# Access Compliance Report

## Public Rights-of-Way

### (Curb Ramps)

Intersection ID: 27409	Main Street: VALLEY_SPRING_DR	Cross Street: WOLF_DEN_LN	Location: N
ADA ID: 68C3CE565BEF	Ramp Type: PerpDiag	Initial Pass/Fail: Fail	Overall Compliance: No
Severity Score: 13.75			
Codes/Mitigation Info/Possible Solution		Field Measurements/Component Compliance

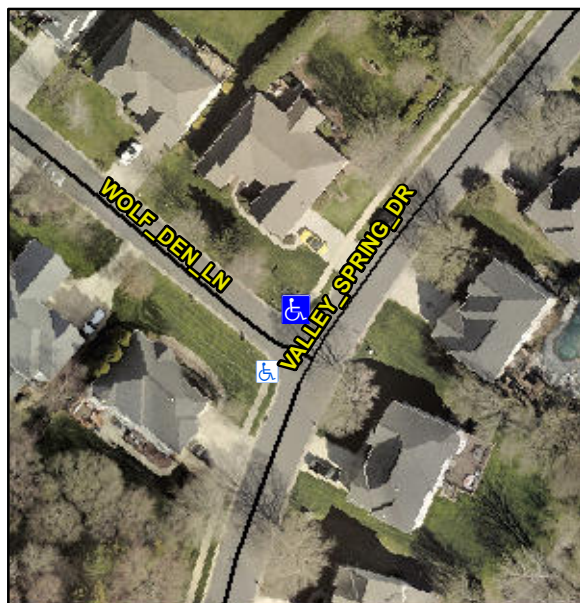
**R304.2.2, R304.5.3**

Compliance	Description	Data	Compliance	Description	Data
N/A	Ramp Length (in)	47.0	No	Ramp Slope (%)	8.4
Yes	Ramp Width (in)	48.0	No	Ramp XSlope (%)	3.5
N/A	Flare Type LT	N/A	N/A	Flare Type RT	N/A
N/A	Flare Slope LT (%)	N/A	N/A	Flare Slope RT (%)	N/A
N/A	Flare Traversable LT?	N/A	N/A	Flare Traversable RT?	N/A
N/A	Landing Length (in)	N/A	N/A	DWS Provided?	N/A
N/A	Landing Width (in)	N/A	N/A	DWS Contrast?	N/A
N/A	Landing Slope (%)	N/A	N/A	DWS Length (in)	N/A
N/A	Landing X Slope (%)	N/A	N/A	DWS Full Width?	N/A
N/A	Landing Curb? (Y/N)	N/A	N/A	DWS Offset (in)	N/A
N/A	Shared Landing?	N/A			
N/A	Gutter Ponding?	N/A	N/A	Gutter Slope (%)	N/A
N/A	Gutter Lip Ht (in)	N/A	N/A	Gutter X Slope (%)	N/A
N/A	Painted X Walk1?	No	N/A	Painted X Walk2?	No
	X Walk 1 Direction	To SW		X Walk 2 Direction	To SE
N/A	X Walk 1 Width (in)	N/A	N/A	X Walk 2 Width (in)	N/A
	X Walk 1 Slope (%)	5.7		X Walk 2 Slope (%)	1.3
	X Walk 1 X Slope (%)	1.4		X Walk 2 X Slope (%)	3.9

N/A	Ramp inside XWalk1?	N/A	N/A	Ramp inside XWalk2?	N/A
	Road Slope (%)	1.2	N/A	Clear Space?	N/A
	Road X Slope (%)	5.6	N/A	Clear Space to XWalk (in)	N/A
N/A	Any Obstructions?	N/A	N/A	Storm Grate/Utility Hazard?	N/A
	Obstruction Type			Storm Grate/Utility Type	
		N/A			N/A
			Yes	Surface Condition? (G/P)	Good

**Remove & Replace Curb Ramp With Two New Directional Ramps or Equivalent.**
